RE: Coachella Valley – San Geronio Pass Subbasin - 2022 Groundwater
Sustainability Plan

**STATEMENT OF FINDINGS REGARDING THE
APPROVAL OF THE
COACHELLA VALLEY – SAN GORGONIO PASS SUBBASIN GROUNDWATER
SUSTAINABILITY PLAN**

Exhibit A: Groundwater Sustainability Plan Assessment Staff Report – Coachella Valley – San Gorgonio Pass Subbasin

Figure 2: Location of Storage Units and Groundwater Monitoring Wells

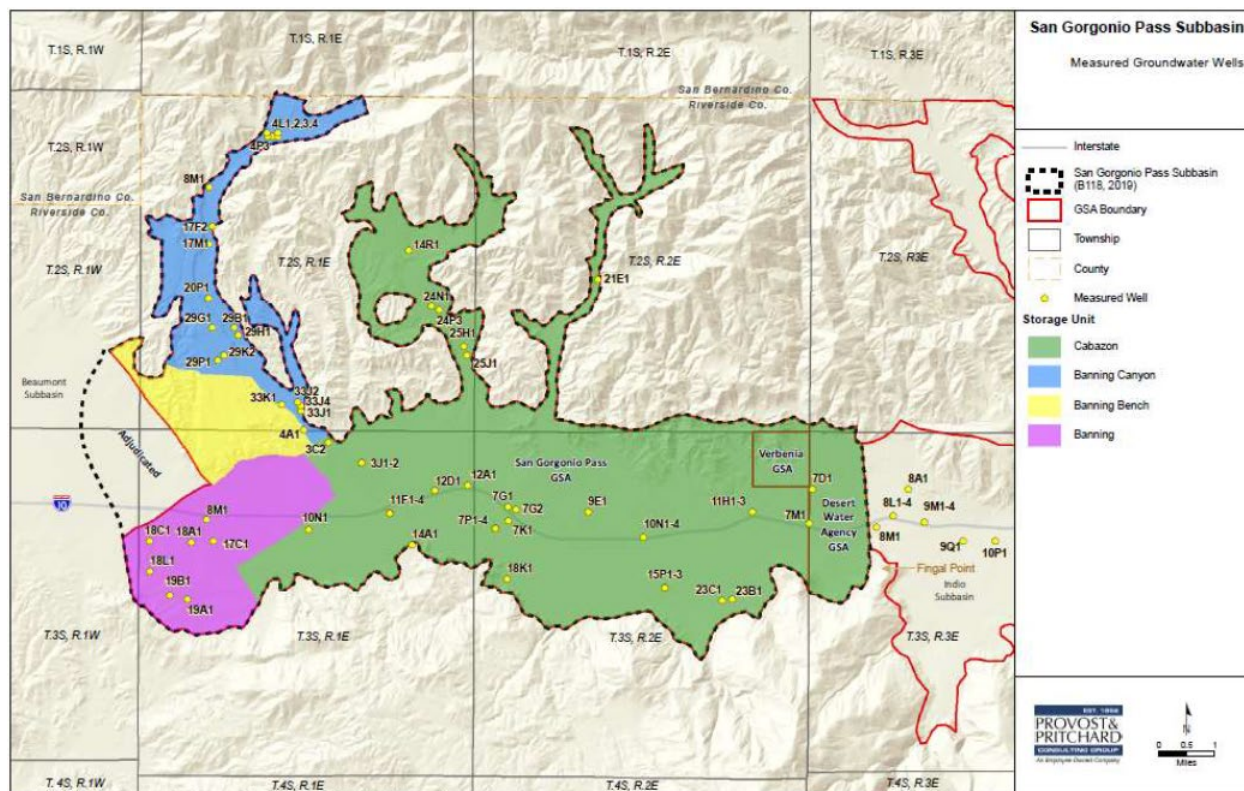
Five hydraulically distinct groundwater storage units have been recognized within the Subbasin. These storage units have been created by geologic faults discussed above that form barriers to lateral movement of groundwater leading to groundwater levels that vary significantly across adjacent storage units. These named units include Beaumont Storage Unit (adjudicated and not under the purview of SGMA), Banning Canyon Storage Unit, Banning Bench Storage Unit, Banning Storage Unit, and the Cabazon Storage Unit.⁶⁵ Refer to Figure 2 for the locations of each of the storage units and refer to the [Section 4.2.4](#) (Management Areas) in this Staff Report for additional details.
